BEFORE THE  
FEDERAL COMMUNICATIONS COMMISSION  
WASHINGTON, D.C.

In the Matter of  
AMENDMENT OF PART 3 (RADIO BROADCAST  
SERVICES) OF THE COMMISSION'S RULES  
AND REGULATIONS AND THE STANDARDS  
OF GOOD ENGINEERING PRACTICE CON-  
CERNING STANDARD BROADCAST STATIONS } Docket No. 10604

REPORT AND ORDER

FIGURE R3  
February 1954

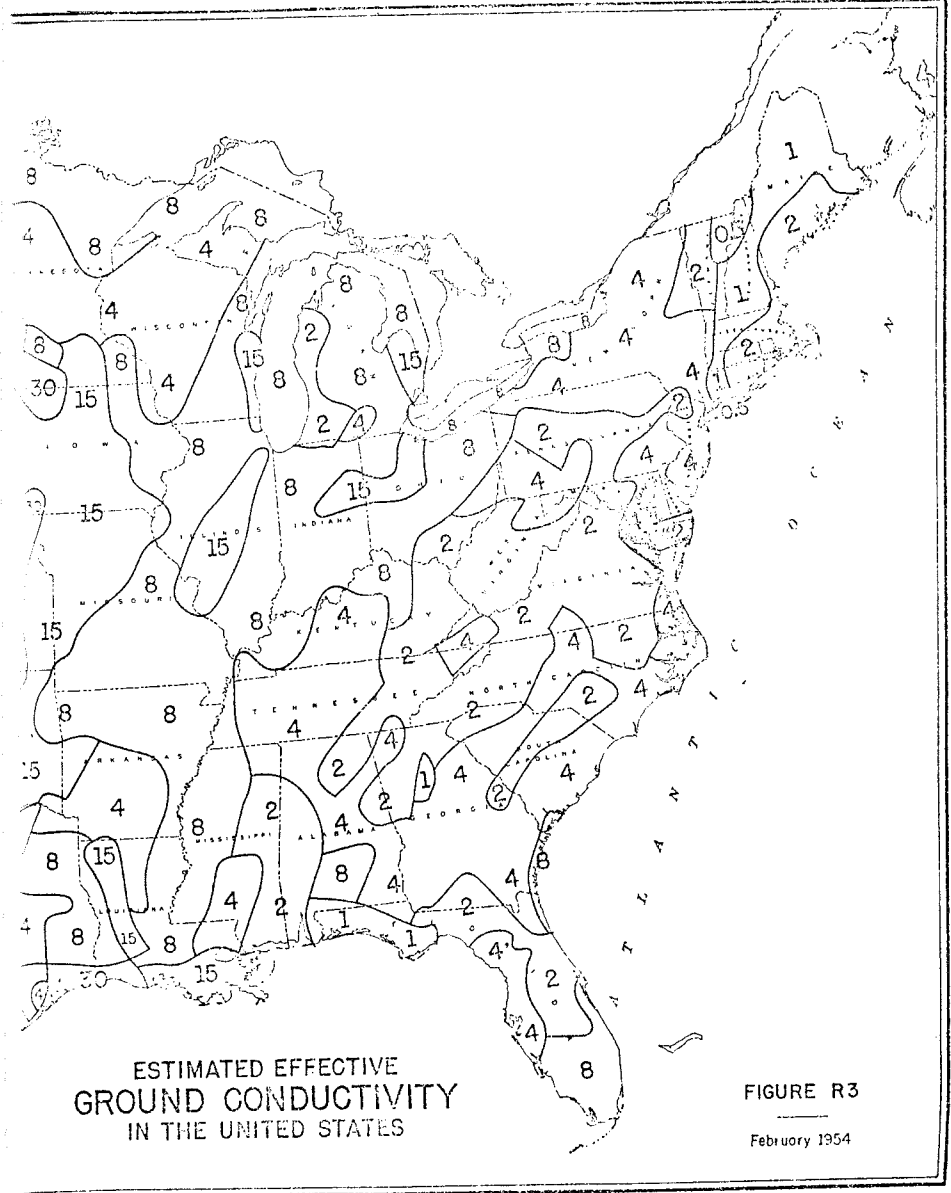
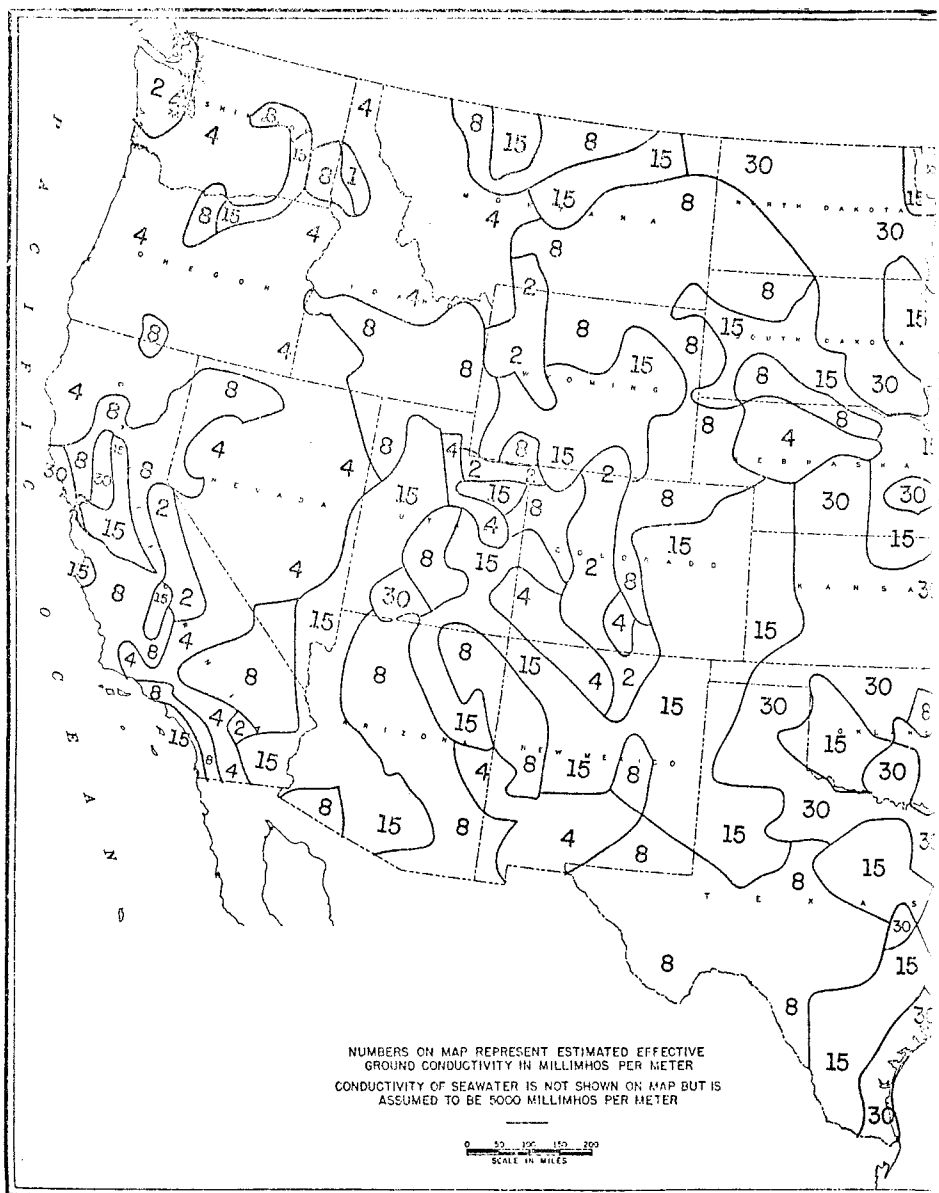
4. Radio Station KMA, Shenandoah, Iowa, filed a comment suggesting changes in conductivity value in an area north of Shenandoah. The Commission's proposed map indicates values 15 and 30 mmhos/m south and north, respectively, of Station KMA. KMA contends that the field intensity measurements filed with its comment show a value of 30 mmhos/m to exist to a point approximately 100 miles north of KMA, and that the line

between 15 and 30 mmhos/m should be moved northward to that point. We have studied the data submitted and find it warrants moving the line about 20 miles northward but that beyond this distance, the conductivity tends to decrease. Accordingly, the map has been modified to show the higher value of conductivity north of KMA but only to the 20-mile extent indicated.

5. The Association of Federal Communications Consulting Engineers filed a comment setting forth several suggestions. First, it points out an error with respect to a corridor of low conductivity, extending through North Dakota. We have corrected the error by ascribing the value of 30 mmhos/m to the area in question.

6. The Association also calls attention to measurements made on a station at Sayre, Pennsylvania northward to Lake Ontario and to the apparent discrepancy between the results obtained and the conductivity value shown on the proposed map. The measurements show varying conductivity values over the three paths measured, with 2 mmhos/m as the most consistent value; with a minor exception, none of the various values indicated is as great as the 4 mmhos/m figure shown on the map. It is implicitly suggested that we have erred either in the assignment of the conductivity value to the area or in the delineation of the line of demarcation between the areas of 2 and 4 mmhos/m, which line is shown to be south of Sayre. We have studied the measurements referred to and the other measurements that originally led us to assign the 4 mmhos/m value to the area and to arrive at the line of demarcation. It is our conclusion that assignment of the 4 mmhos/m figure and retention of the present demarcation line is warranted by the preponderance of measurements pertaining to the area. In this connection, it is pointed out that the map does not purport to give precise values along particular paths and therefore, the narrow refinement sought is inappropriate.

10. Certain changes not suggested by parties to this proceeding have also been made. Thus, we have noted an error in our placement of a portion of the line of demarcation between the areas of 4 and 2 mmhos/m in central Maryland, and are accordingly moving the line somewhat northward so as to include Baltimore and its environs in the area shown as having a conductivity value of 2 mmhos/m. Also, there has come to our attention field intensity measurement data which indicates that an area in south central Michigan is not accurately represented by the value of 8 mmhos/m shown by the proposed map; the map has therefore been revised to reflect the proper value for this area and to move the western line of demarcation. Finally, on the basis of certain field intensity measurements filed with the Commission, the area from east to central Utah, which is shown as having a value of 8 mmhos/m, is modified so that the value 15 mmhos/m is set out and slight changes are made in the lines of demarcation about the area.

IV. Figure 3 is deleted from these Standards and Figures M3 and R3 substituted therefor. Figure M3 is substituted and incorporated into the Standards by reference. Figure R3 is attached.
